CERTIFICATE OF APPROPRIATENESS

Property: 1913 A Crockett St, Lot 11A, Block 314, Crockett Street Landing Subdivision. The property is a vacant lot, subdivided into two lots – 1913-A, which fronts on Crockett St, measures 2,534 square feet (51' x 50'-4"); 1913-B at the rear is 1,608 square feet (37'-8" x 42'-8").

Proposal: New Construction – Residence/Garage *Deferral*

Construct a 2,000 square foot two story L-shaped residence and attached garage.

BLOCKFACE SITE PLANS

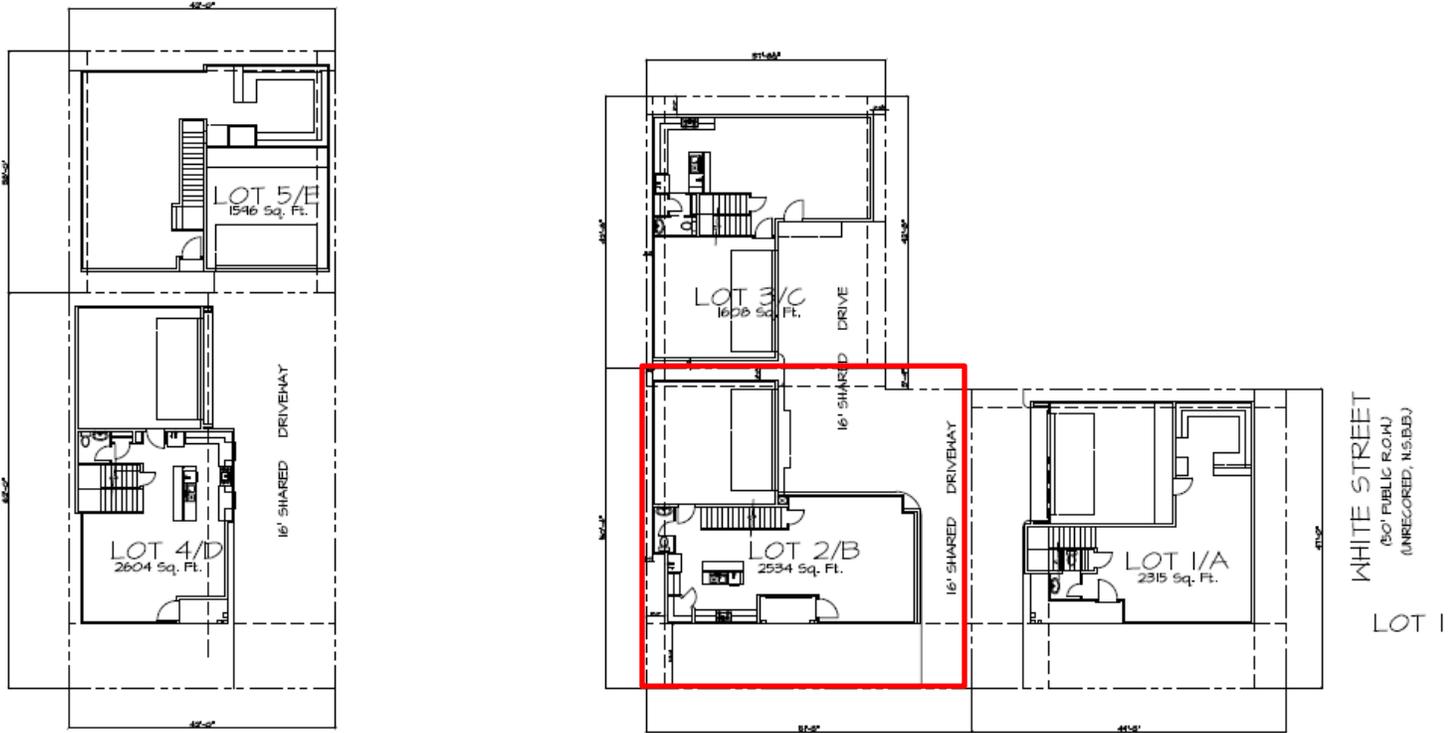
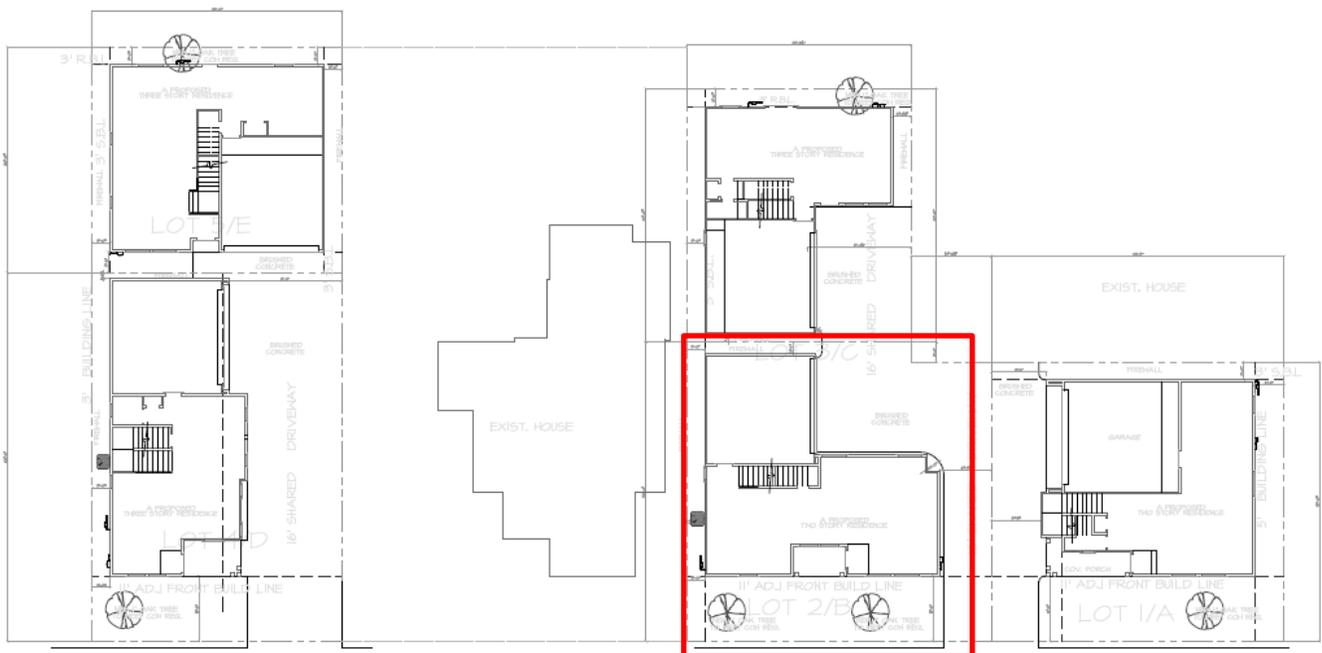
- There is one contributing structure on this blockface that has a setback of 11'. The residence is setback 11' from the front and 4' from the east which places the new structure approximately 7' from the contributing structure at 1907 Crockett.*

- 1.4. The historic/contributing structure at 1907 Crockett is known to encroach on its neighbor to the west (1913 Crockett). This encroachment is not shown on the site plan. This omission is significant, since it affects the actual distance that will separate the new structure at 1913 from the existing one at 1907.

- 1.5. A 10' setback from the street is noted. This is out of character for the District, where setbacks of 15 feet or more are prevalent on contributing structures. Is this permissible?

NORTH ELEVATION – FRONT FACING CROCKETT STREET

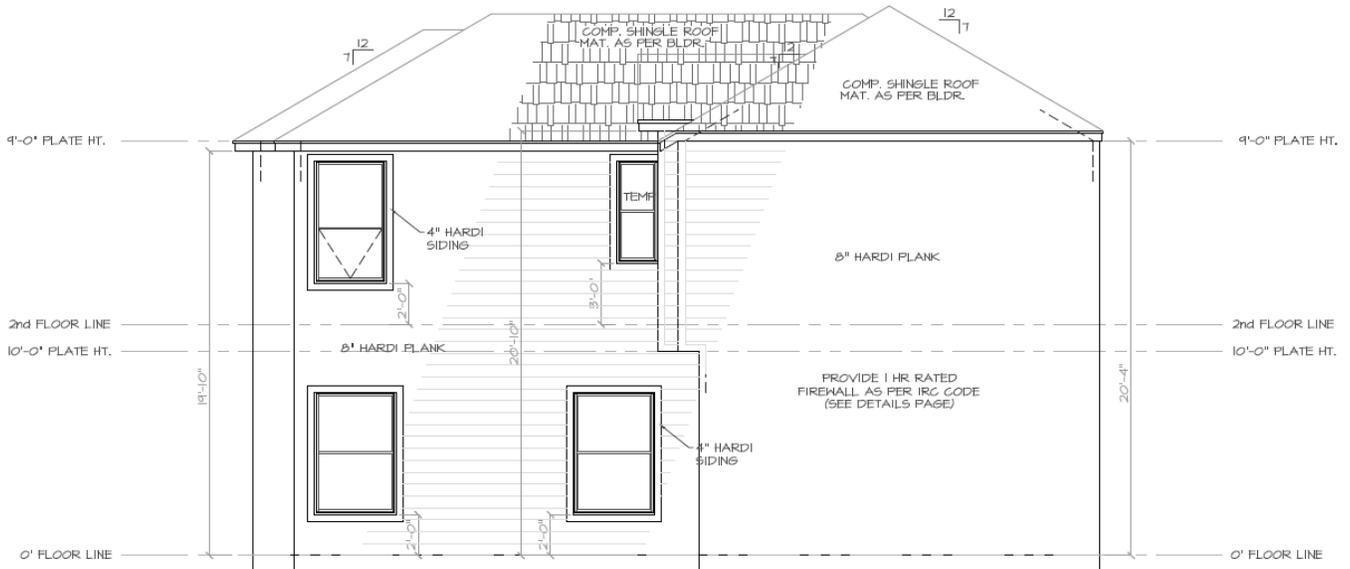
- At the February and March meetings, the Commission suggested following the trend in the historic neighborhood of differing architectural styles along the street and referencing the contributing structure at 1809 Summer Street. The applicant has designed a residence with features that reference, but do not copy, the historic structure such as the square front opening instead of an arched opening, and the absence of detailed brick work and an arched parapet above the entrance.*

EAST SIDE ELEVATION

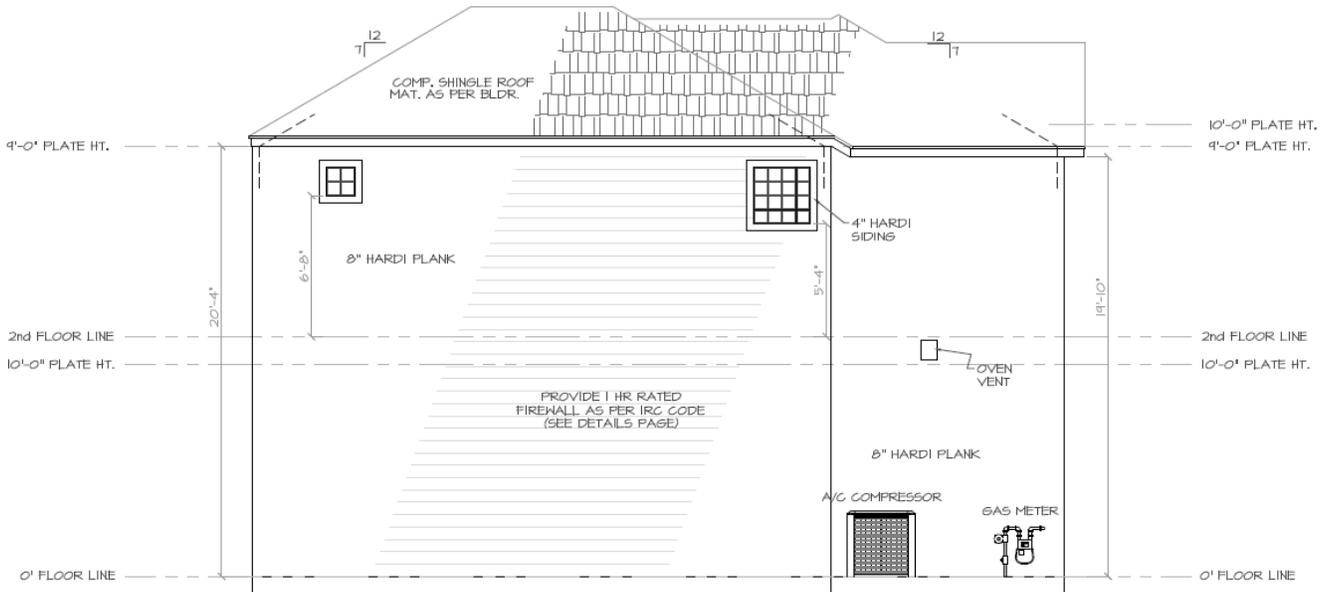
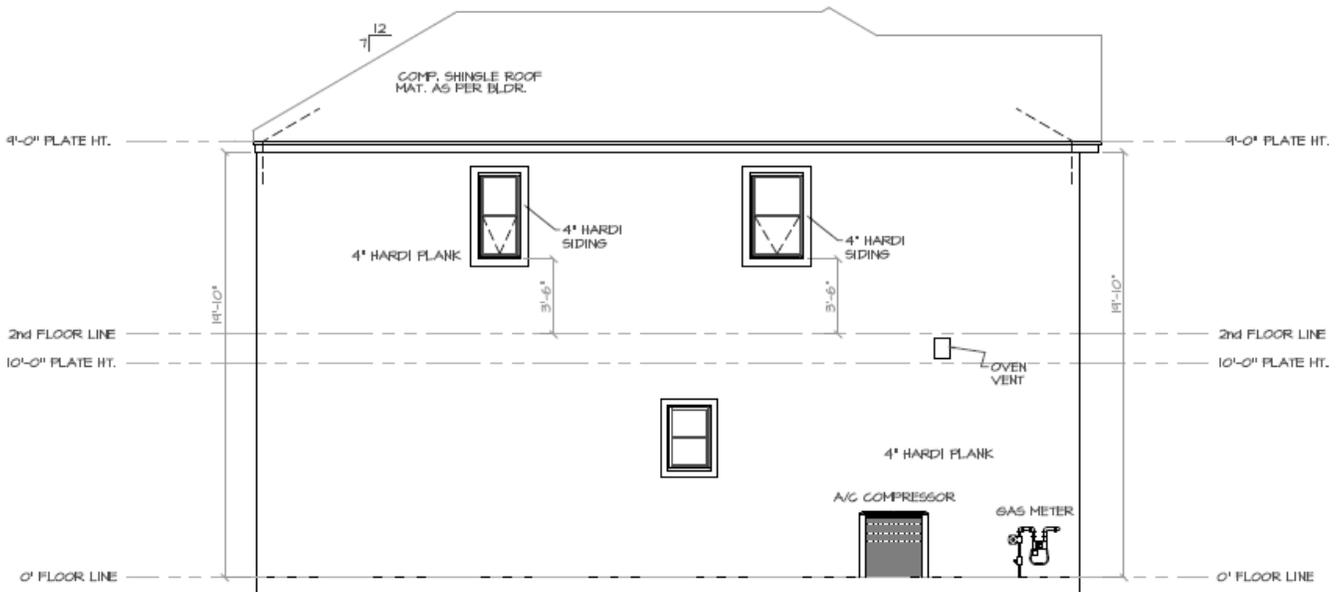
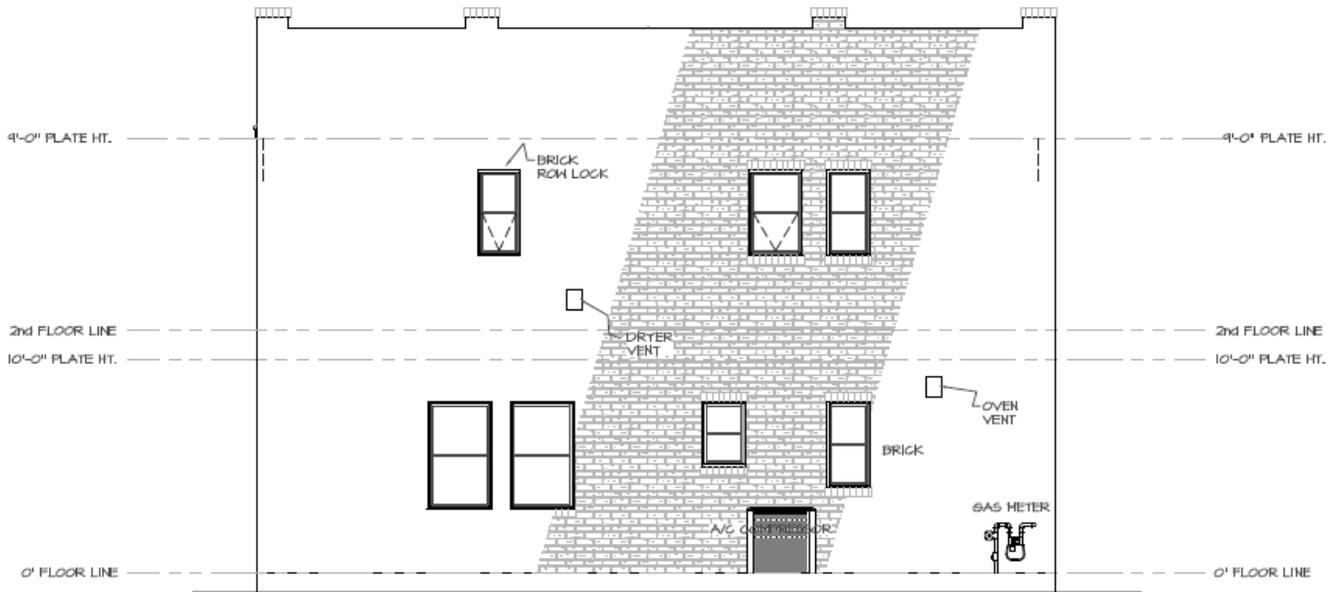
- The fenestration changes made to the east and west elevations meet the solid to void ratio requirements outlined in the design guidelines.*
- The inset front entrance is approximately 6' deep which is compatible with porch depths in the context area.*

The draft Design Guidelines also requires traditional solid-to-void proportions for walls to windows. The fenestration changes made to the east and west elevations meet this provision.
